# SERVICE LETTER

No. 864

Piper Aircraft Corporation

Subject: Forward Cabin Door Stop (Striker Plate) Installation

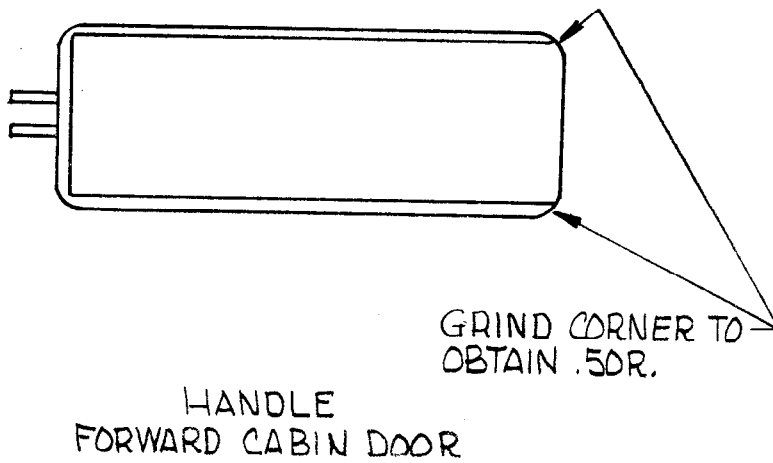
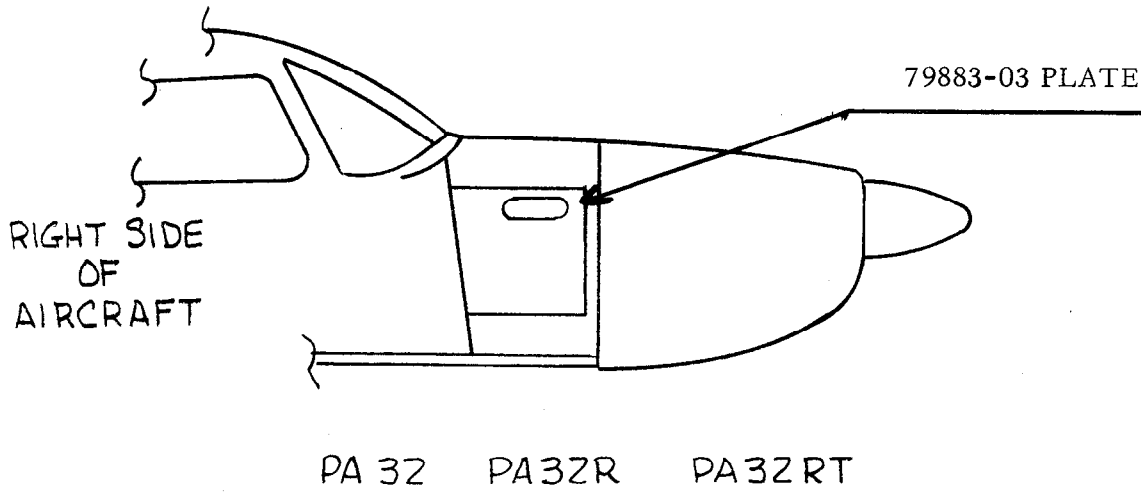
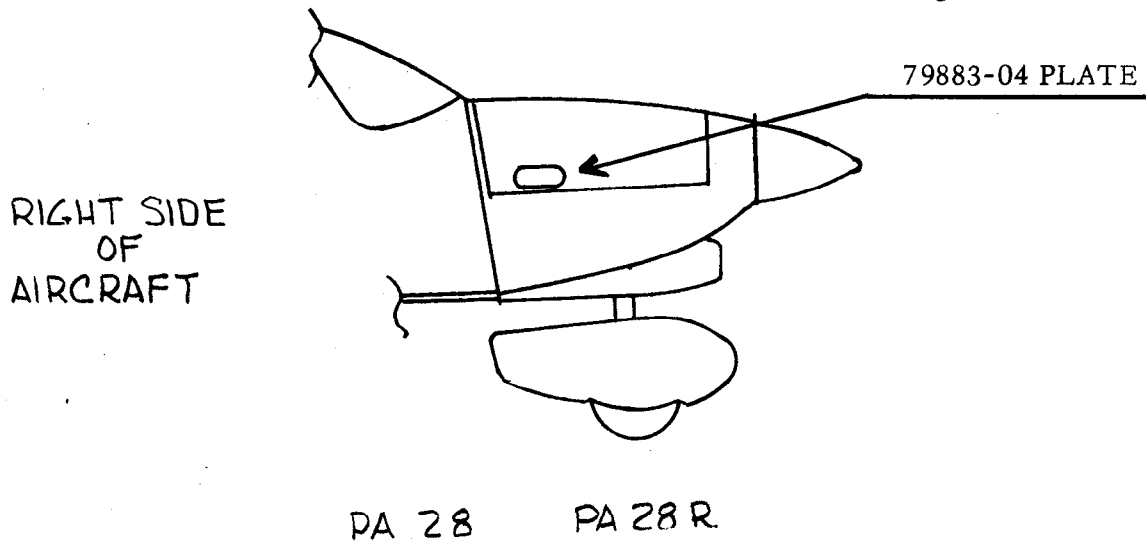
There is a possibility that should a high wind shear the rivet in the forward cabin door holder (stay), the door could swing beyond its normal limit and contact the fuselage or engine cowling. If this happens, the door handle can damage the fuselage or cowling.

PART I provides instructions for installing a striker plate on the fuselage or cowling to prevent damage. The instructions also require the rounding off of the corners on the outside door handle which will assist in moving the handle to the closed position should the handle contact the striker plate.

1. Remove the forward cabin door holder, (stay) attachment screw from the door sill.
2. Allow the door to swing forward beyond its normal limit until it almost touches the forward baggage door or the engine cowling.

3. Open the outside door handle (full open) and mark the fuselage or engine cowling at the point where the end of the door handle contacts either the baggage door or the engine cowling. See PART I sketch.

4. Install the striker plate (see Material Required for correct plate for model concerned), using the previously determined point of contact from Instruction 3, to locate the forward attaching rivet.

5. Align the striker plate parallel with the bottom edge of the cowl or; where the striker plate is installed on the forward baggage door, align the striker plate parallel with the upper hinge line of the baggage door.

6. Install the striker plate using two (2) each Piper part number 420 693 (MS20426-A3-7) rivets. Where the striker plate is installed on a fiberglass cowling, use one (1) each Piper Part Number 407 560V (AN960-3) Washer next to the fiberglass on the bucked end of each rivet.

7. With the forward cabin door outside handle fully open, grind off the forward top and bottom corners to .50 radii. See PART I sketch.
8. Reinstall the forward cabin door holder (stay) attachment screw in the door sill which was removed in Instruction number 1.
